**Comment Summary – November 21, 2024 (4<sup>th</sup> Submission)**  
**Zoning By-law Amendment Application – WDD Main St. Inc.**

**Re: Zoning By-Law Amendment 4th Submission  
11 Main Street (Morrison)  
Puslinch, ON**

**RE:** Hydrogeological Review Comments – 4<sup>th</sup> Submission  
WDD Main Street Inc. – 11 Main Street, Morriston (Puslinch), Ontario  
Proposed Residential Subdivision  
Zoning By-law Amendment / Draft Plan of Subdivision Application

**LEGEND**

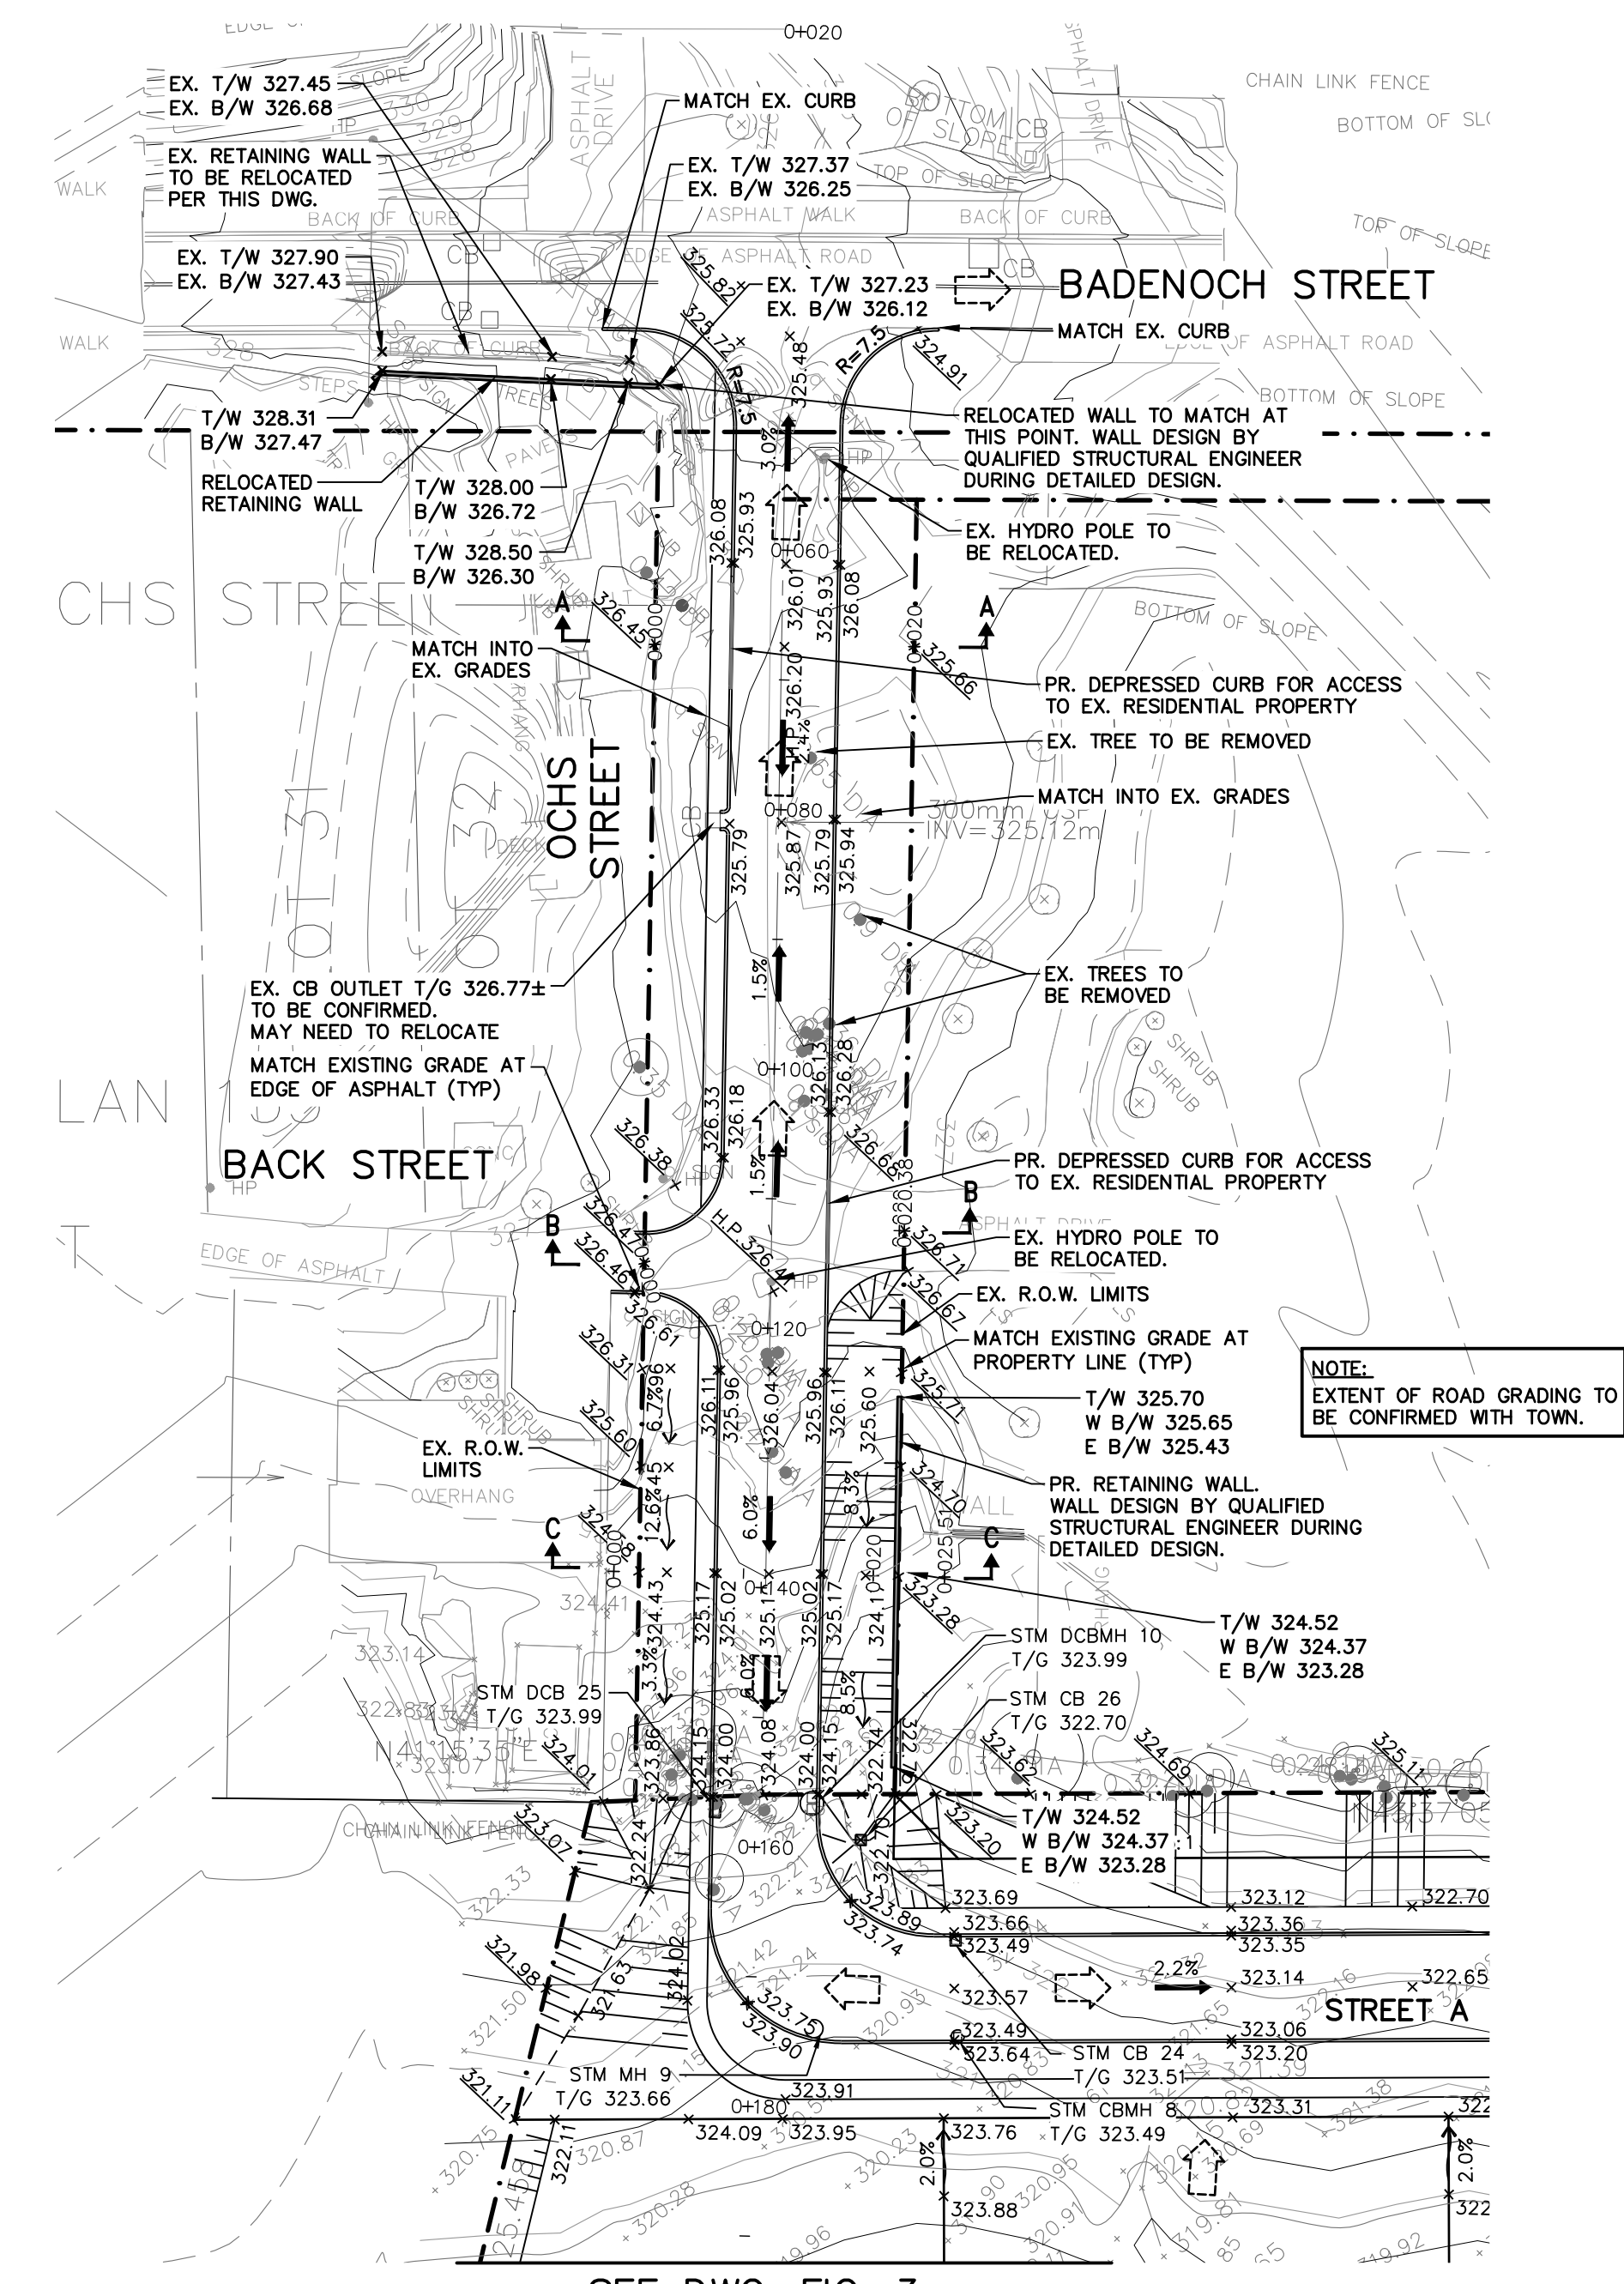
17.	Ponding at Catchbasin	Engineering Plans	February 9, 2024, September 27, 2024	<p><u>GEI Comment (February 9, 2024)</u>            The Site Grading Plan shows that proposed catchbasin CB 36 has a T/G elevation of 316.89, which is 1.5m lower than the adjacent curb elevation proposed. Considering the proximity of CB 36 to the property line, there is concern that stormwater will pond onto the neighbouring property at catchment EX2.            Please show that the storm sewer leaving CB 36 will have the capacity to convey the flow generated by EX2 with ponding contained to the subject property up to and including the 100yr storm event. Additional topographic survey may be required on the adjacent lands.</p> <p><u>Crozier Response (September 2024)</u>            CB 27 (formerly CB 36) and the receiving storm sewer system have been designed to convey the 100-year storm event. The sizing was complete utilizing Visual Otthymo and Flowmaster. Further details will be provided at detailed design.</p> <p><u>GEI Comment (September 2024)</u>            Per Puslinch development standards, storm sewers are to be designed using the rational method and a <b>storm sewer design sheet</b> is to be provided to demonstrate that the 100-year storm can be conveyed. The first reach of the storm sewer in the cul-de-sac bulb should have a slope of</p>

No.	Matter	Document	Date Identified	Comment
				<p>at least 1%, currently it is shown as 0.5%. All other storm sewer should have a slope of at least 0.5%.</p> <p>As discussed with Crozier staff, additional topographic data may be required to show the 100-year storm event ponding limits at detailed design.</p> <p><u>Crozier Response (November 2024)</u>            Sewers have been designed to convey the minor system (5-year event). Major storms are proposed to be conveyed via overland flow within the right-of-way and will spill into the pond at low point in the development.</p> <p>The first reach of storm sewer in the cul-de-sac bulb has been adjusted to 1%.</p> <p><u>GEI Comment (December 13, 2024)</u>            We note that one stretch of storm sewer (CBMH 11 – DCBMH 12) has a slope of 0.4%, which is lower than Township standards, however the flow velocity is within the allowable range per Township Standards.</p> <p>No further comment.</p>

Drawing  
**POST-DEVELOPMENT  
DRAINAGE PLAN**

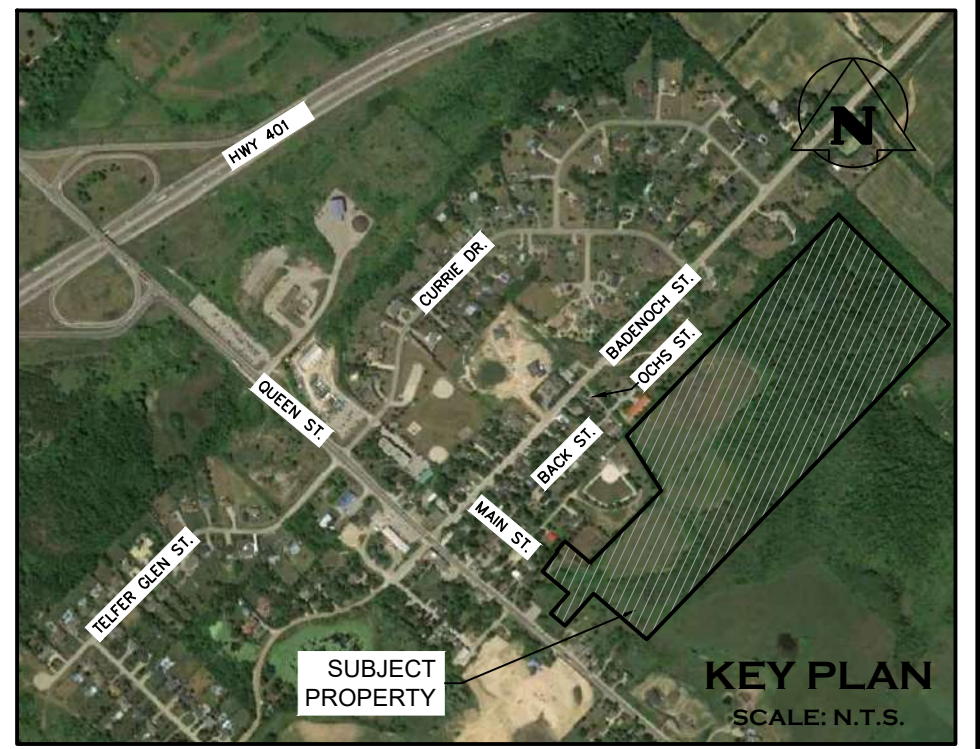
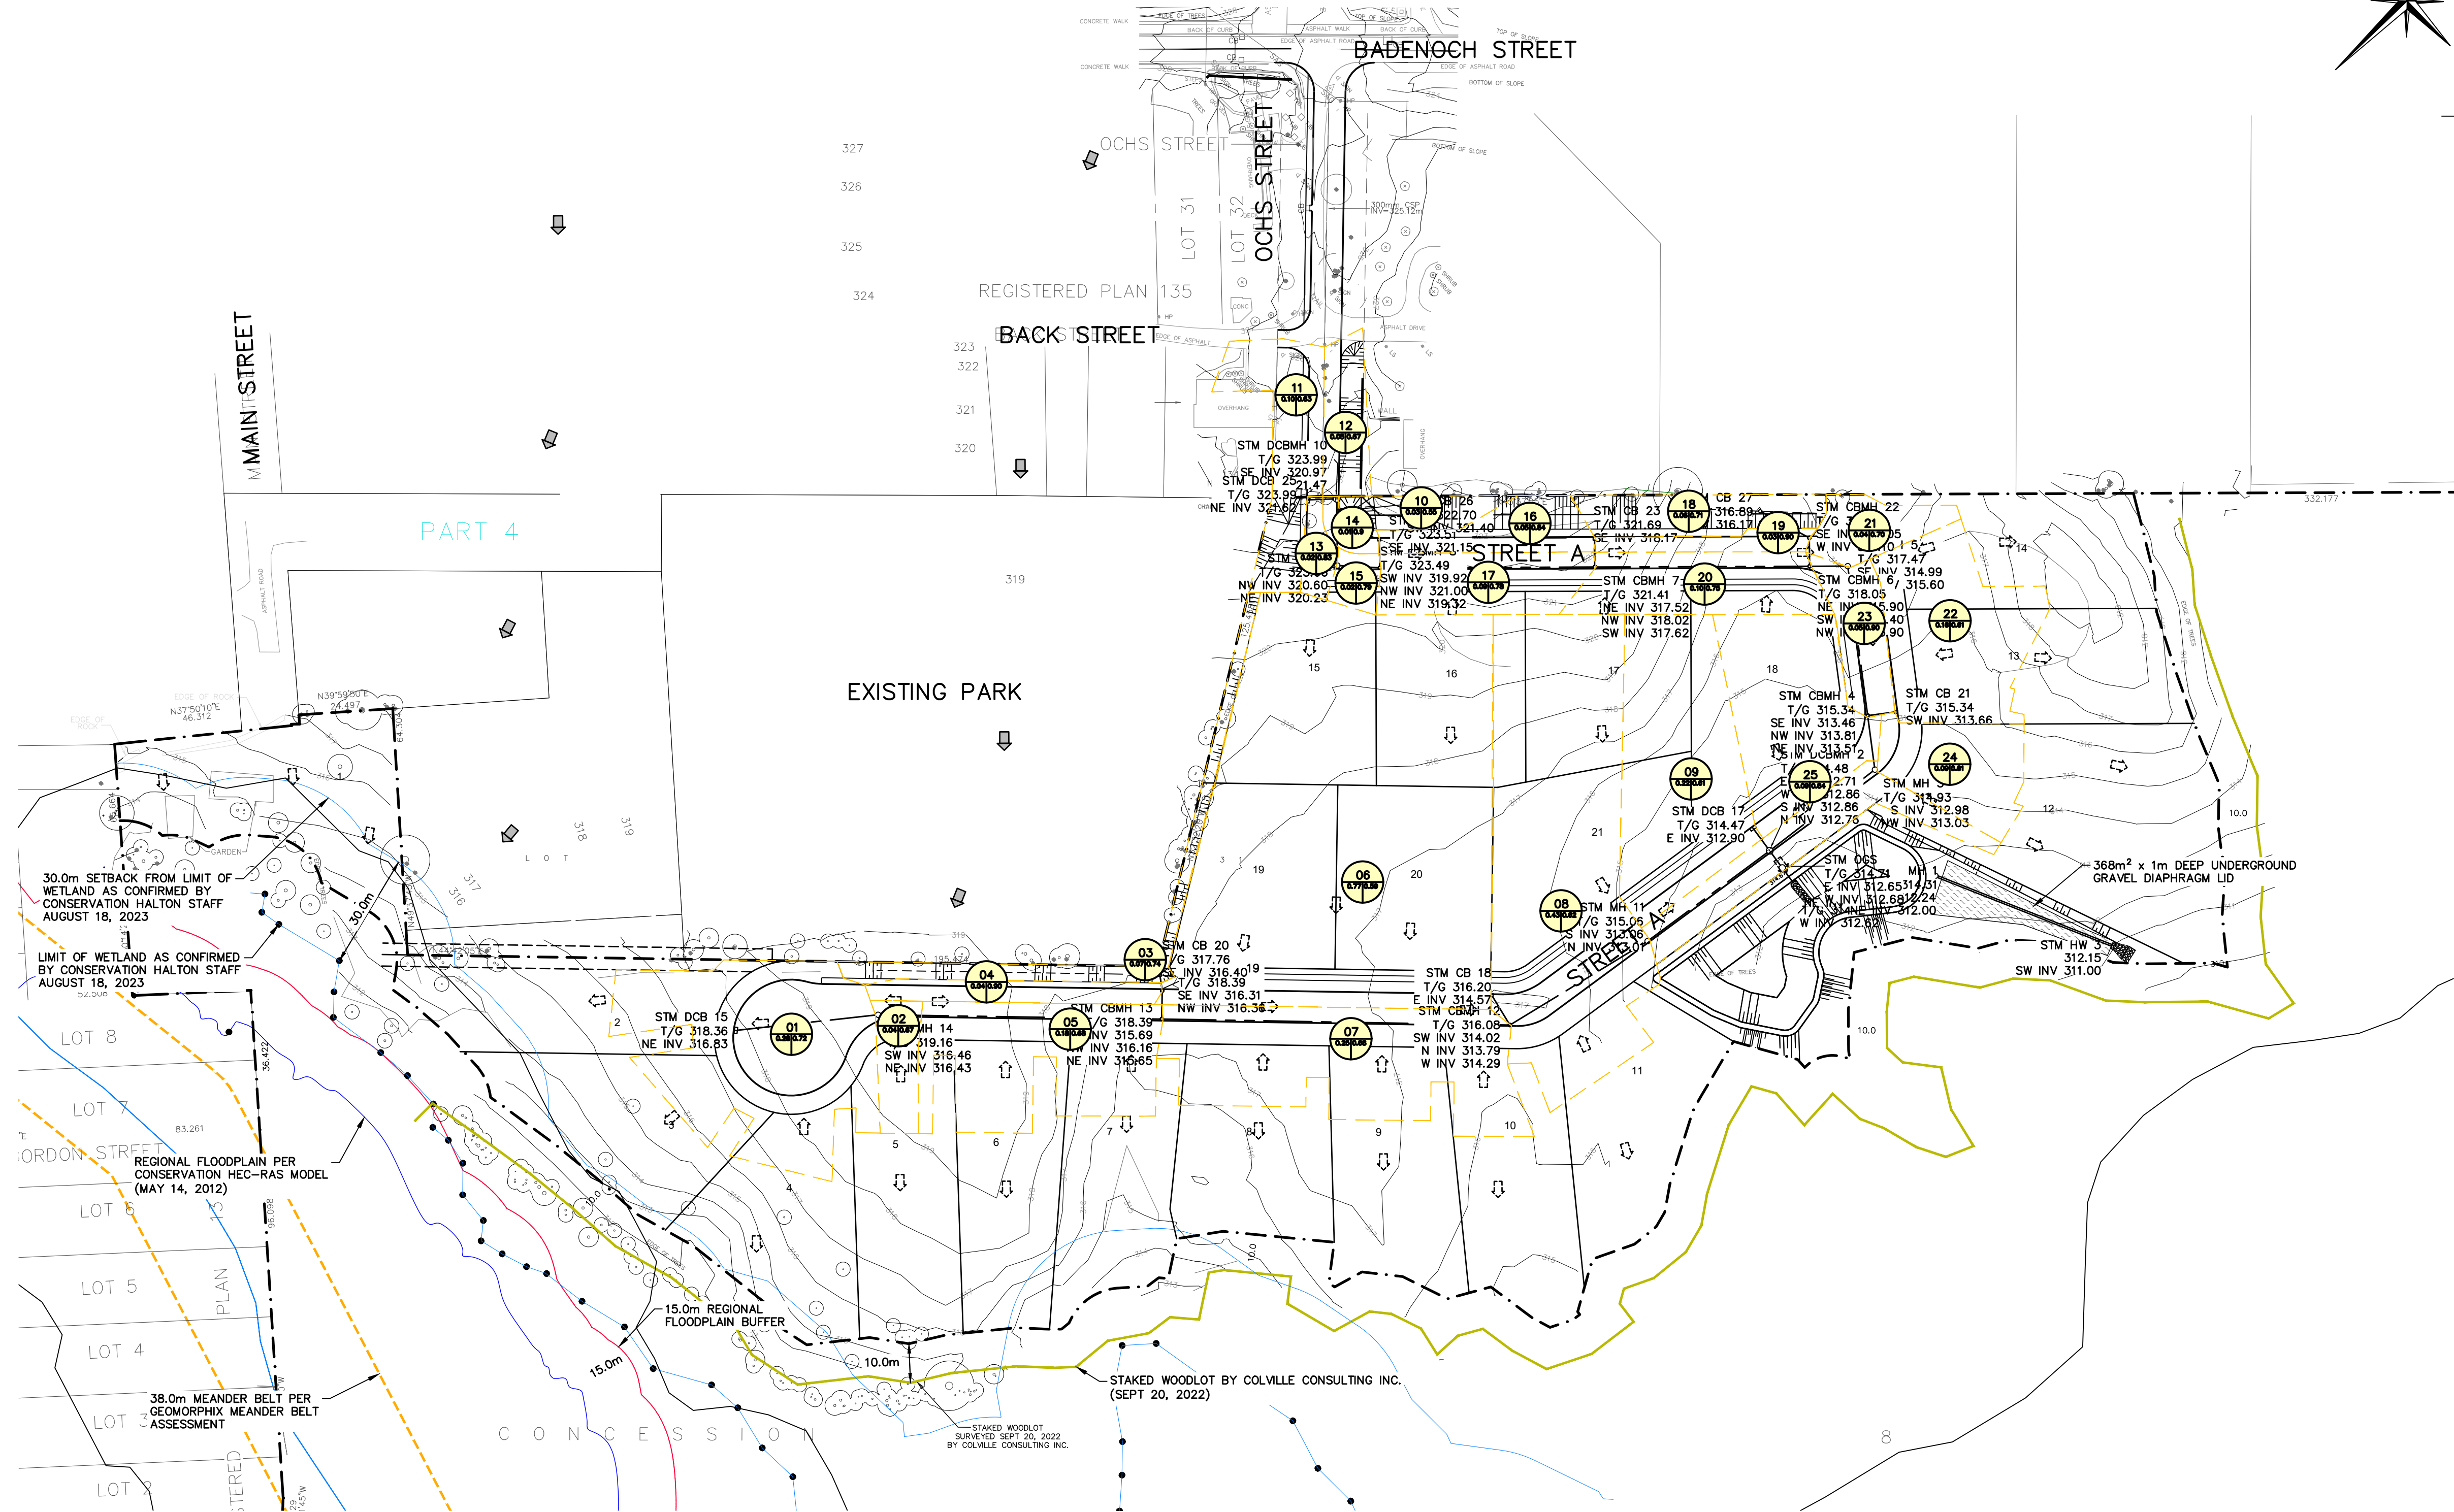
6.	Post-Development Drainage Plan	FSR	April 20, 2023	<p><u>GEI Comment (April 20, 2023)</u>                      Please label the imperviousness of the external areas on the Post-Development Plan for consistency.</p> <p><u>Crozier Response (January 2024)</u>                      The Post-development Drainage Plan has been revised to include the imperviousness of the external drainage catchments.</p> <p><u>GEI Comment (February 9, 2024)</u>                      Accepted, no further comment.</p>
